MAINE TURNPIKE AUTHORITY

ADDENDUM NO. 2

CONTRACT 2024.06

BRIDGE REPAIRS

MTA PROJECT NO. 2024.06 BRIDGE REPAIRS MAINTENANCE OF TRAFFIC DETAILS (01 OF 02)	
VHB: 55729.00	SHEET NUMBER: 5
CONTRACT: 2024.06

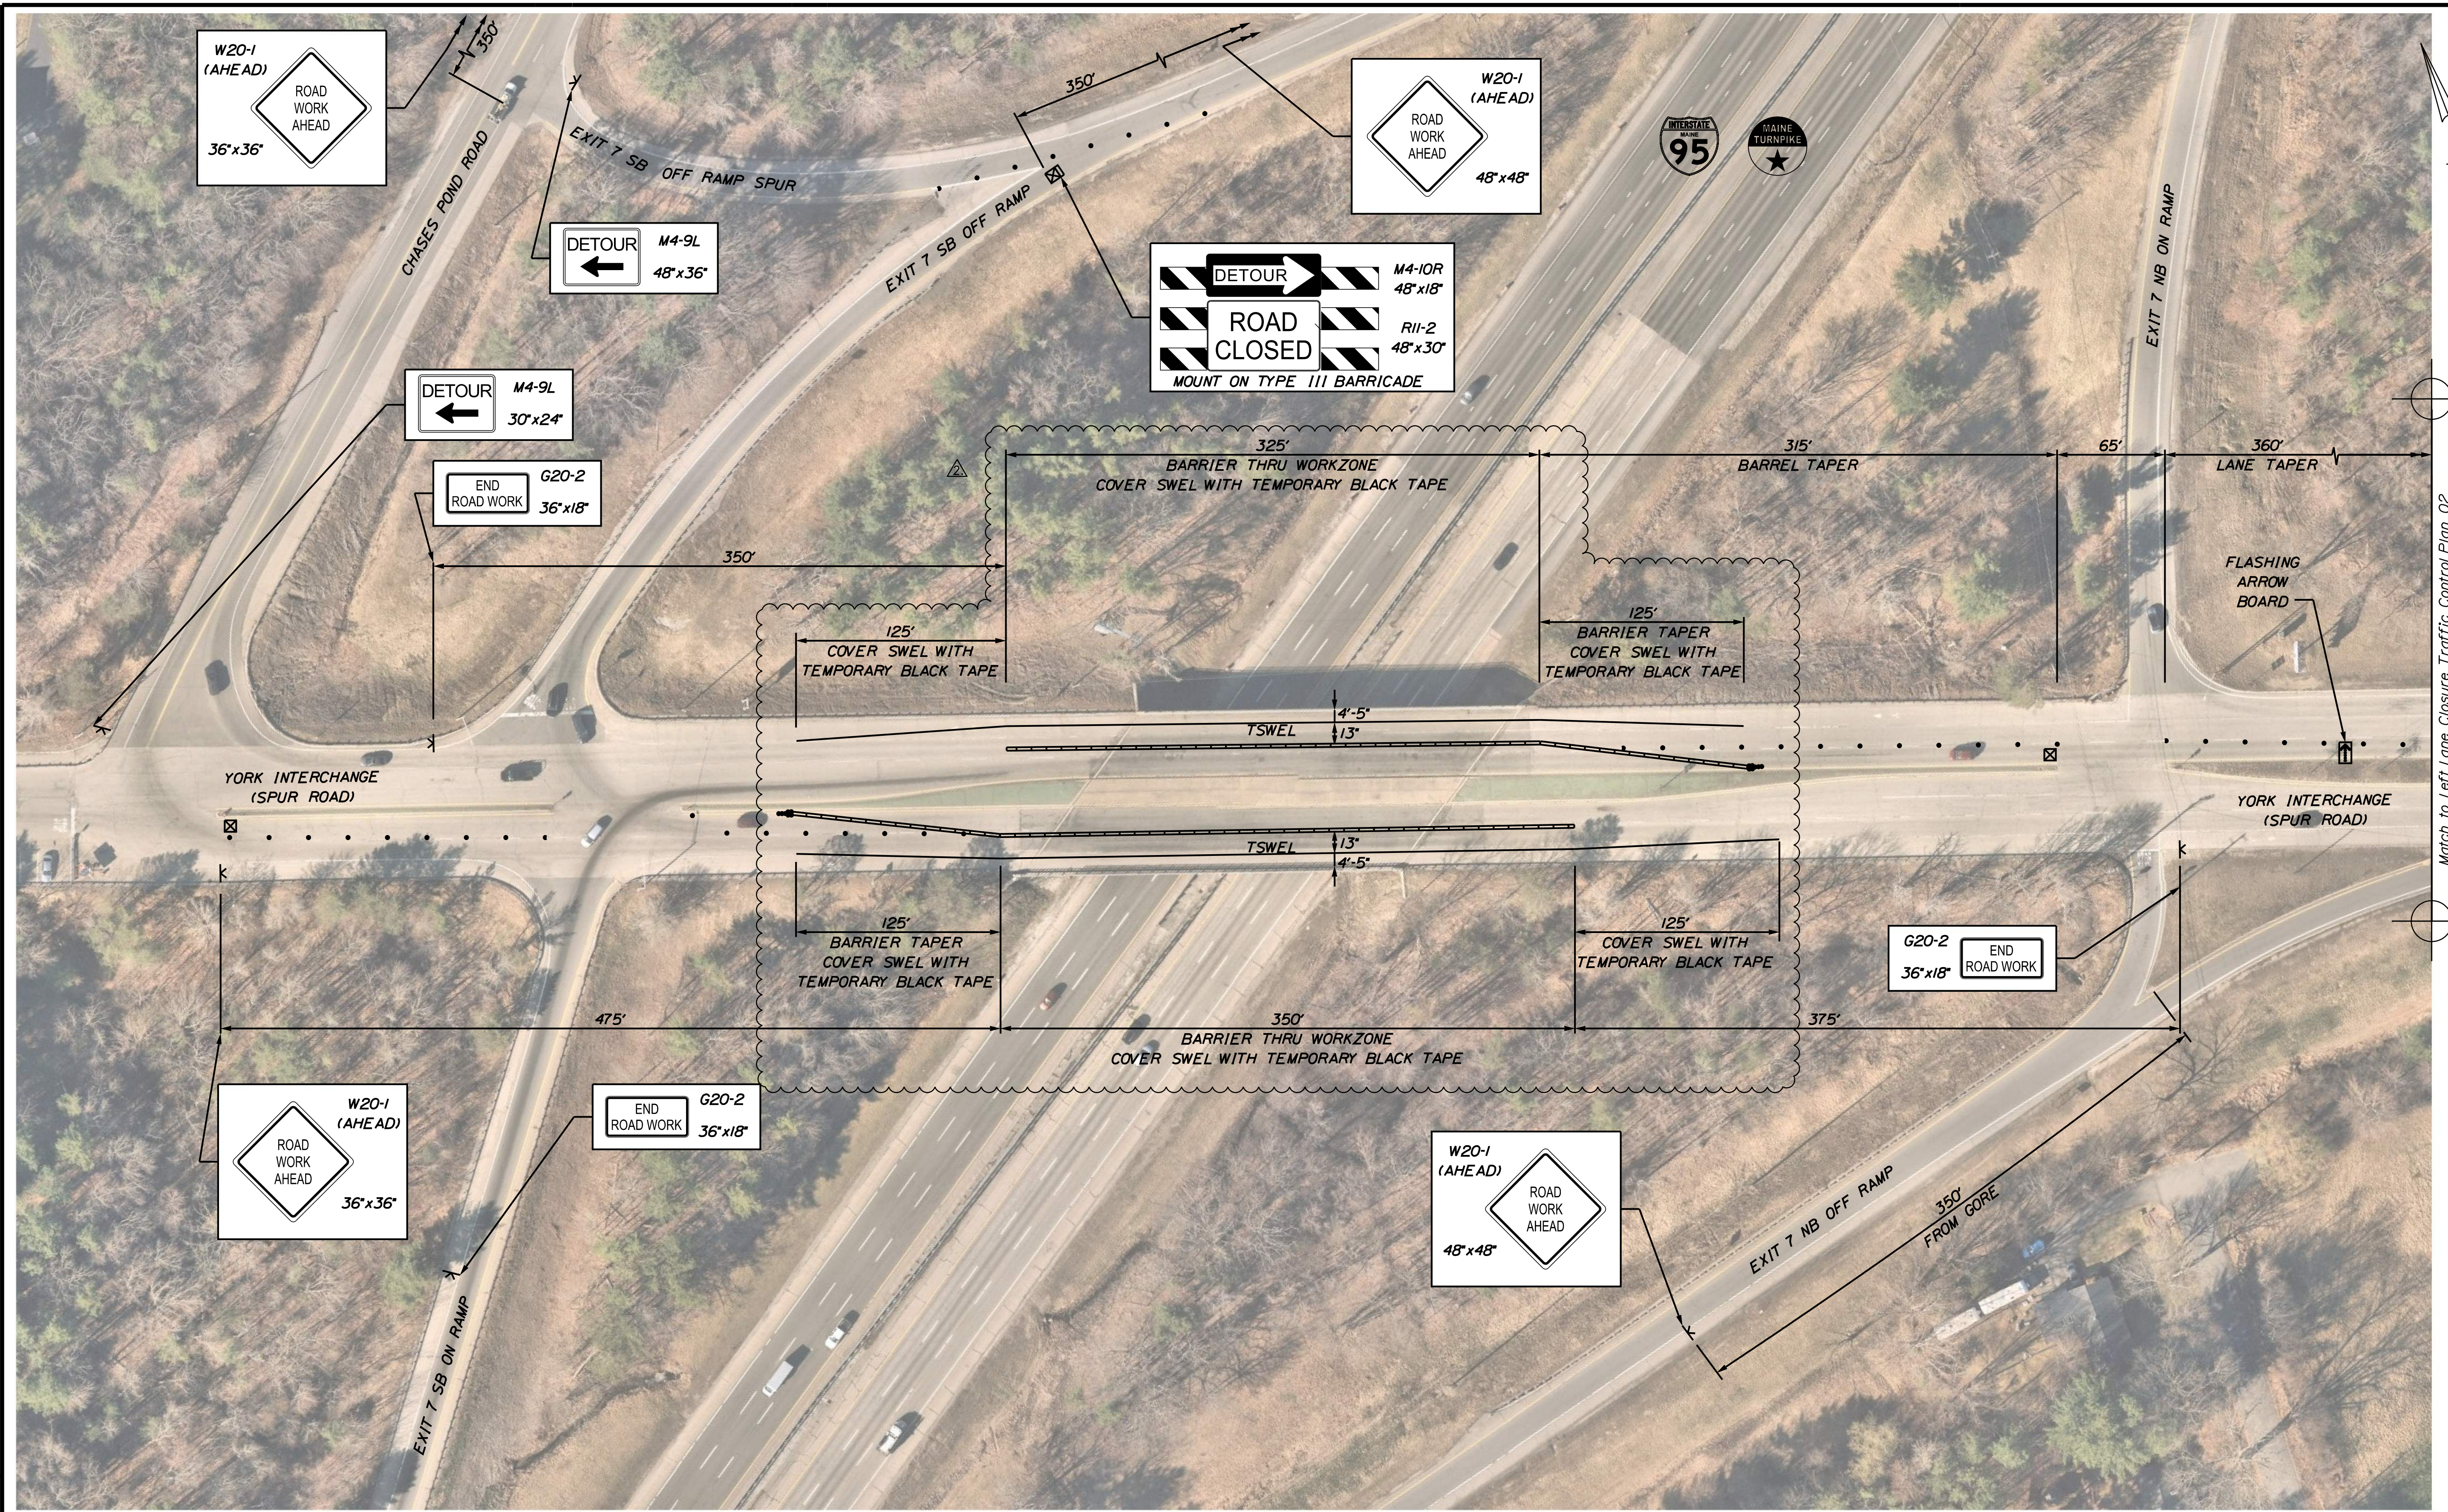
Question 1: We would prefer to work behind temporary barrier at the York Interchange Underpass. Would MTA consider adding temporary barrier to the traffic control plans?

In the Plans, **REMOVE** Sheets 2, 5, 7, 9, and 11 and **REPLACE** with the attached revised Sheets 2, 5, 7, 9, and 11. **ADD** the attached Sheets 10A and 10B.

Response: *Yes, see changes outlined below.*
